Address
**34 FOUNTAINS AVENUE
SIMONSTONE**

drawing title PROPOSED GROUND & FIRST FLOOR PLAN		
drawn by JL	date 17/03/26	
scale 1:50 @ A1	Drawing no. 2025/03	revision C

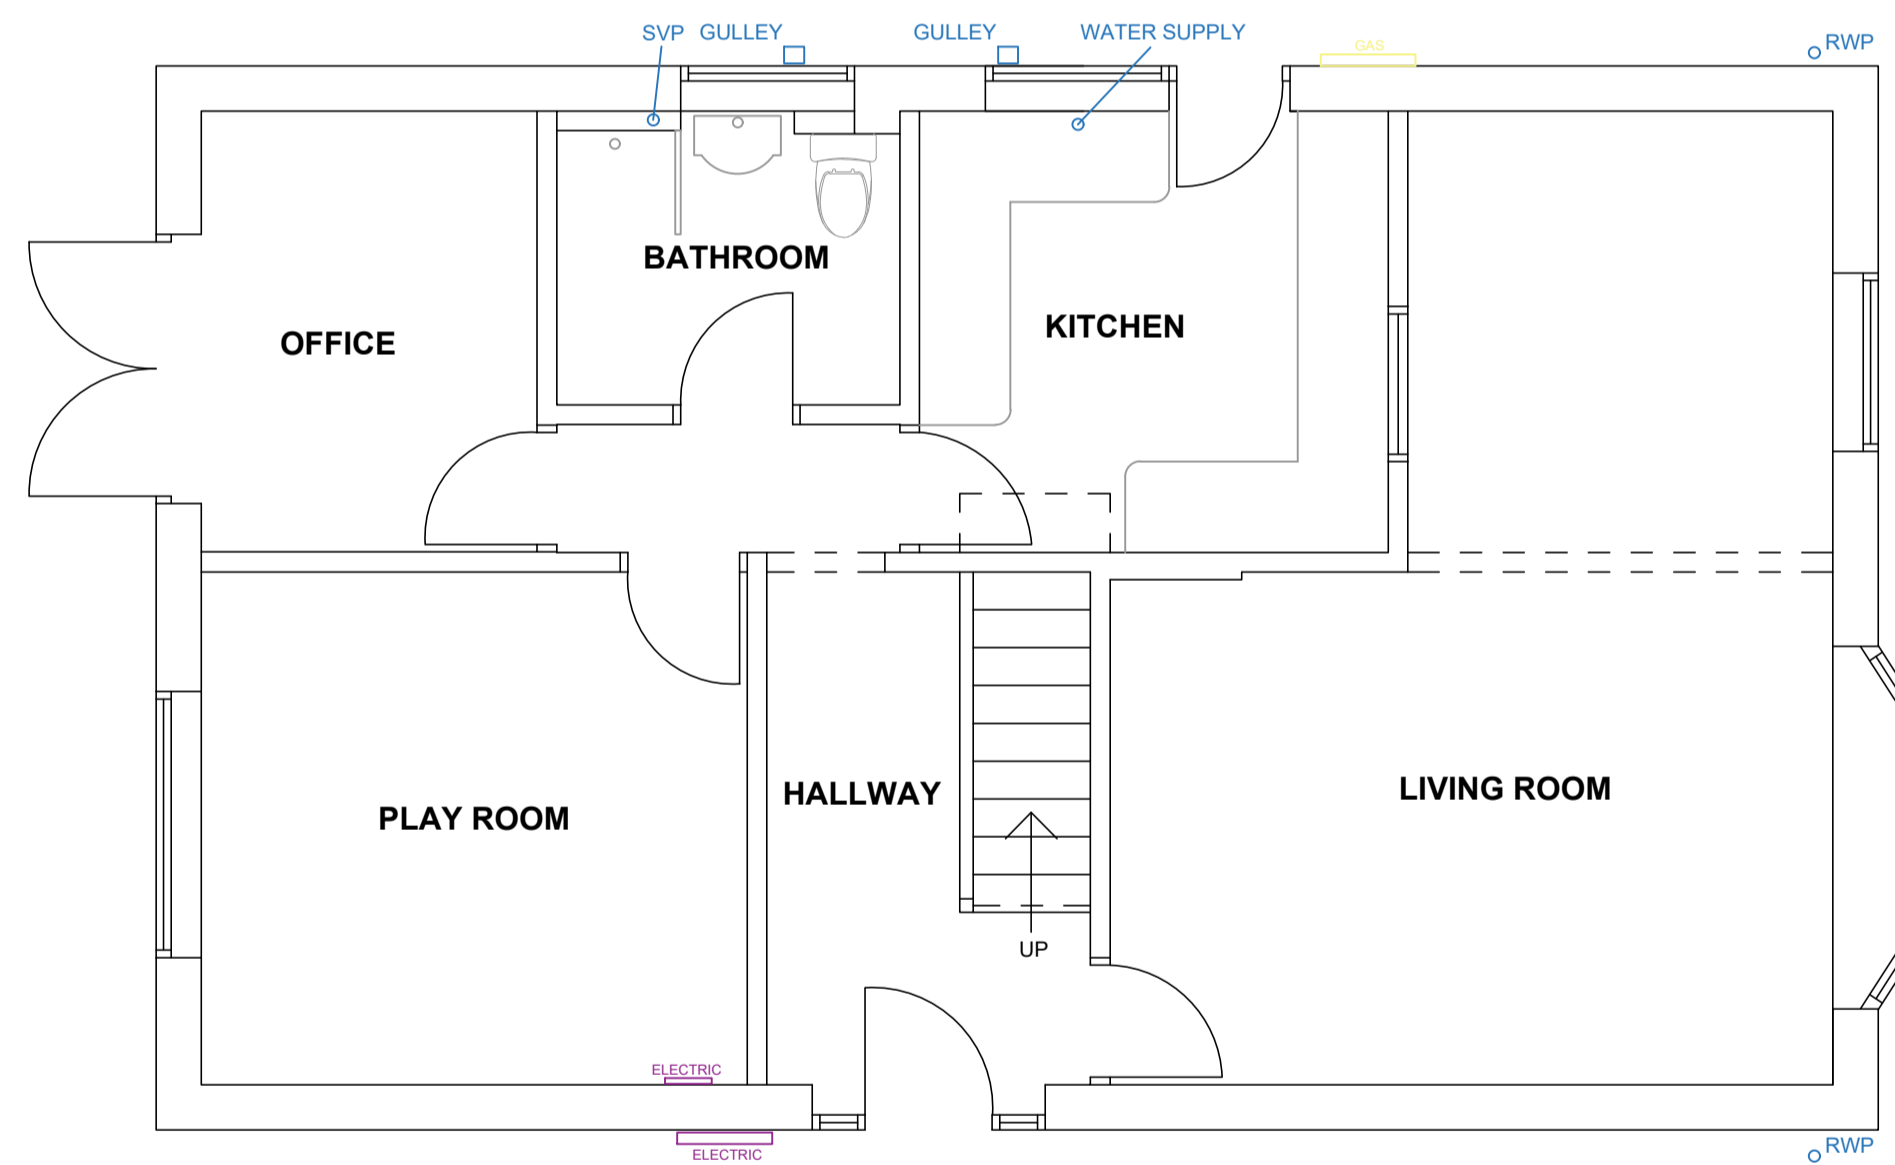
rev	date	description
C	28-04-26	Updated to suit clients comments: windows increased to 1.5m wide.
B	22-04-26	Dressing room added, bathroom reduced and attic hatch relocated
A	29-03-26	Updated to 3 bedroom layout
